Council Reserves Report

SPECIALIST ADVICE - ASSESSMENT FOR RESOURCE CONSENT APPLICATION

Comments due by:	2 APRIL 2021	Processing Planner:	Mark Batchelor - CKL
Consent number:	SP/0179/20		
Address:	1881 CAMBRIDGE ROAD CAMBRIDGE		
Applicant:	3Ms of Cambridge Limited Partnership		
Agent:	Abbie Fowler – Mitchell Daysh		
Allocated to:	Anna McElrea, Senior Reserves Planner		
Date of site visit:

Figure 35. Structure Plan Comparison – 3Ms Site

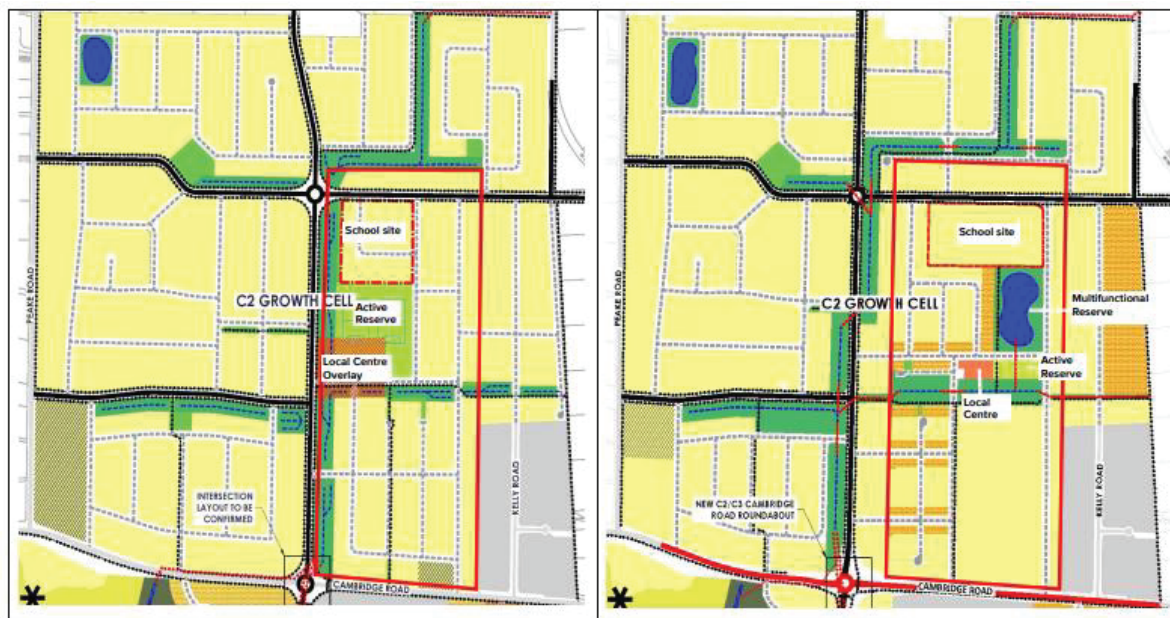
The application does however significantly vary from the structure plan layout applied to the site (see Figure 35 of the application below) in terms of the size, location and nature of the proposed recreation reserve, and the adjoining land use and roading and stormwater networks. The application only includes a 5,151m² neighbourhood reserve (lot 501) rather than a 4-5ha active reserve. This active reserve was intended to provide playing fields and a cricket oval adjoining the proposed school site and commercial centre which in addition to contributing to meeting the demand for sports field playing hours, would have also enabled the creation of a large central high quality open space with destination playground, large specimen trees and off road shared tracks that would have acted as a community hub and events space for the C1, C2, C3 and C7 growth cells.

Other key differences to the wider open space network (including streetscape and stormwater reserves) are movement of the proposed north-south drainage reserve connections providing for a continuous shared path network and the north-south collector road to the west of the 3Ms site and the creation of a large central stormwater reserve.

Figure 4: 3Ms plan of walking and cycling network

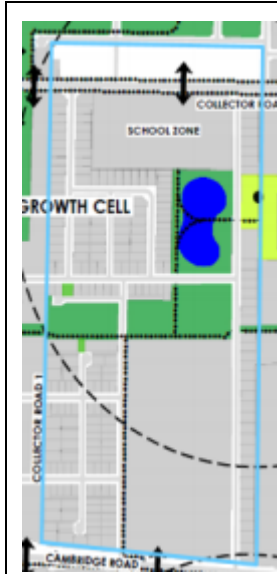
The plan of the walking and cycling network included in the 3Ms subdivision consent application shows:

- An on-road shared path network on the proposed collector road next to the school
- An off-road shared path network extending through the drainage reserves in an east west direction, and extending from Cambridge road north to the school

Note: a reserve shown in the plan at left that provides a second shared path link to the east is not shown on the proposed scheme plan.

Figure 5: Stormwater design

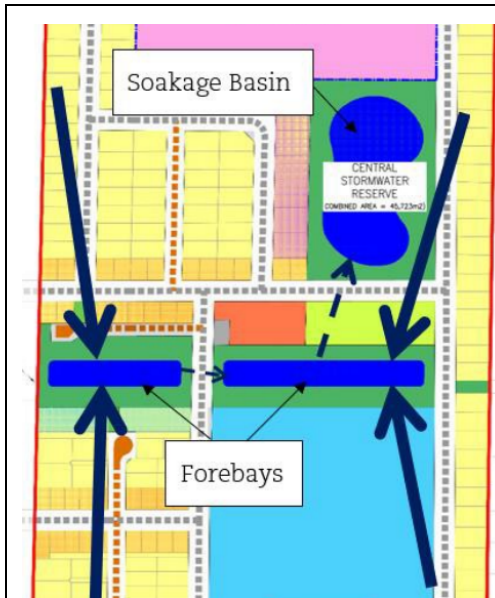
The application notes the 'Stormwater from larger events, or in the case of blocked pipes, will be conveyed overland along road and reserve corridors to the central soakage system', and this is indicated in Figure 17 of the application (excerpt at left).
